ADDENDUM #2

PROJECT: Thousand Islands Secondary School
HVAC Replacement & Upgrades
PROJ. NO.: 24078
DATE: April 29, 2026

ROOF PLAN

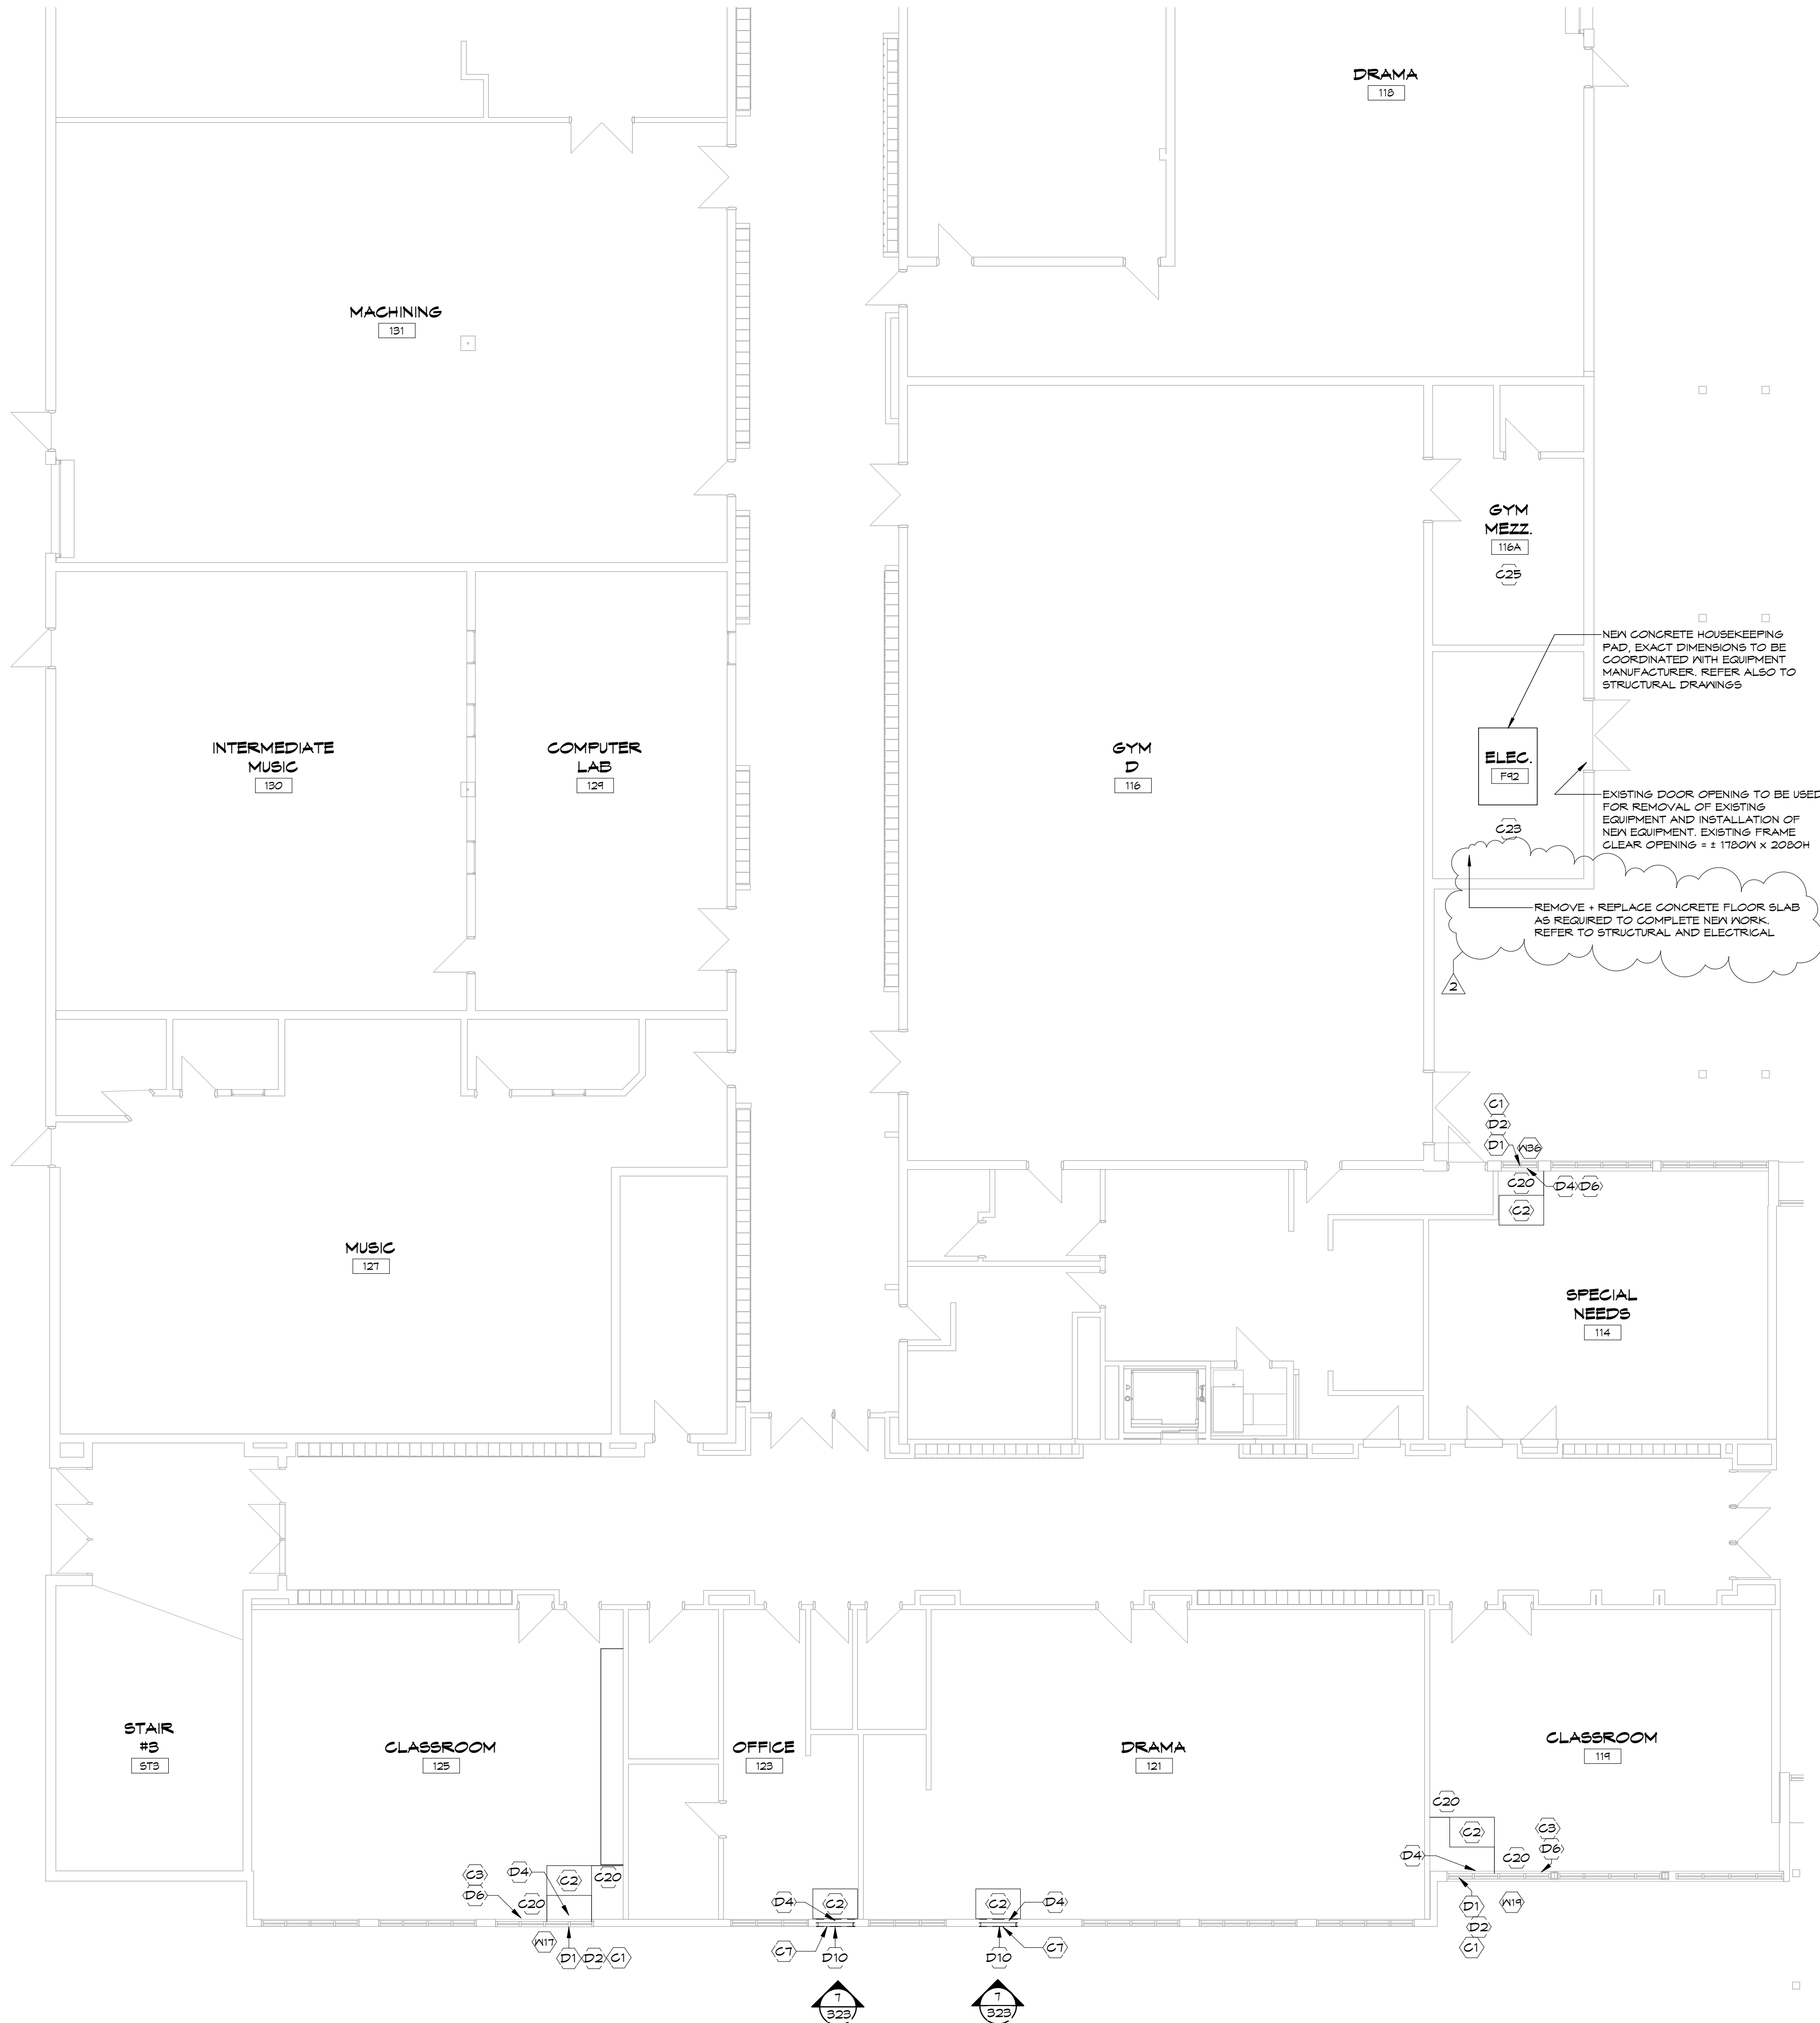
4. Q: Architectural drawing 303 shows a plumbing vent to be relocated. It is not on the roofing drawings to relocate vent or patch roof. Please clarify
A: The vent relocation is indicated on roofing drawings 1 and 2 and the detail is on drawing 5.

5. Q: Architectural drawing 303 note R7 says modify existing roof curb to accept new duct. Mechanical drawing M305 says to elbow into existing opening. Please clarify.
A: The intent is to keep the existing roof opening and roof curb and adjust the curb to suit the smaller duct.

6. Q: Architectural Drawing 303 notes R9 and R10 say to remove HVAC equipment AND curb, patch roofing to match existing. Roofing Drawing 2 note 1 says infill curb with insulation and cap as per details 8/4 and 4/3. Please clarify which is to happen
A: Refer to revised drawing 303, existing roof curbs to remain and be capped.

21. Q: Architectural drawing 303 note R12 - there doesn't appear to be any insulated metal wall panels - please clarify what product is to be used to patch at HVAC removal.
A: Wall may be patched with a prefinished metal siding to match existing colour and profile. Openings to be insulated.

REMOVE EXISTING DUCT/FAN/UNIT, ROOF CURB TO REMAIN. INSULATE AND PROVIDE NEW PREFINISHED METAL CAP, COLOUR TO MATCH EXISTING METAL FLASHINGS
